20 January 2016

**Tri-County Aggregates Ltd.**

Re: **Noise Impact Study for the Proposed Tri-County Pit**  
Response to Valcoustics Peer Review December 9, 2015

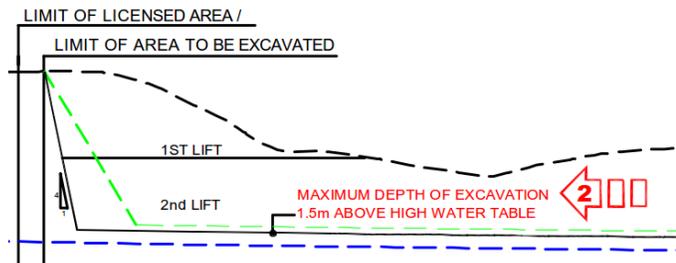
12. *Clarification is requested for Stage 2 operation. The recommended extraction direction is towards R06 but the figures appear to show extraction progressing away from R06.*

Stage 2 will be extracted in two lifts. As the topography rises significantly on the south side, the first lift only includes a small south side portion. The report figures provide this; Figure 4 illustrates the extraction of Stage 2 1<sup>st</sup> Lift, and Figure 5 illustrates an extraction operation on Stage 2 2<sup>nd</sup> Lift. A section illustrating the topography and extraction lifts is provided below. This illustration is part of the Operational Plan drawing.
